# Access Compliance Report

## Public Rights-of-Way

### (Curb Ramps)

Intersection ID: 30337	Main Street: DULIN_CREEK_BV	Cross Street: GOLD_PAN_RD	Location: NE
ADA ID: 6AF7FA4E7A68	Ramp Type: PerpDiag	Initial Pass/Fail: Fail	Overall Compliance: No
Severity Score: 33.75			
Codes/Mitigation Info/Possible Solution		Field Measurements/Component Compliance

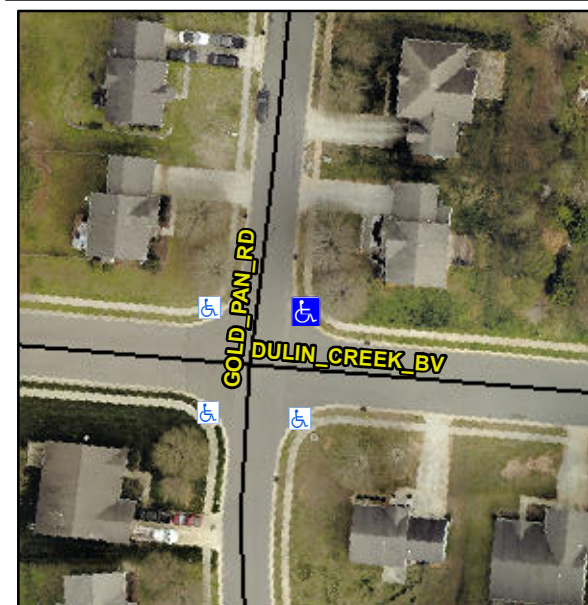
**Not Found, R304.5.1, R304.2.2**

Compliance	Description	Data	Compliance	Description	Data
N/A	Ramp Length (in)	47.5	No	Ramp Slope (%)	15.7
No	Ramp Width (in)	47.0	Yes	Ramp XSlope (%)	0.5
N/A	Flare Type LT	N/A	N/A	Flare Type RT	N/A
N/A	Flare Slope LT (%)	N/A	N/A	Flare Slope RT (%)	N/A
N/A	Flare Traversable LT?	N/A	N/A	Flare Traversable RT?	N/A
N/A	Landing Length (in)	N/A	N/A	DWS Provided?	N/A
N/A	Landing Width (in)	N/A	N/A	DWS Contrast?	N/A
N/A	Landing Slope (%)	N/A	N/A	DWS Length (in)	N/A
N/A	Landing X Slope (%)	N/A	N/A	DWS Full Width?	N/A
N/A	Landing Curb? (Y/N)	N/A	N/A	DWS Offset (in)	N/A
N/A	Shared Landing?	N/A			
N/A	Gutter Ponding?	N/A	N/A	Gutter Slope (%)	N/A
N/A	Gutter Lip Ht (in)	0.5	N/A	Gutter X Slope (%)	N/A
N/A	Painted X Walk1?	No	N/A	Painted X Walk2?	No
	X Walk 1 Direction	To W		X Walk 2 Direction	To S
N/A	X Walk 1 Width (in)	N/A	N/A	X Walk 2 Width (in)	N/A
	X Walk 1 Slope (%)	0.6		X Walk 2 Slope (%)	0.7
	X Walk 1 X Slope (%)	1.7		X Walk 2 X Slope (%)	4.0

**Remove & Replace Curb Ramp With Two New Directional Ramps or Equivalent.**
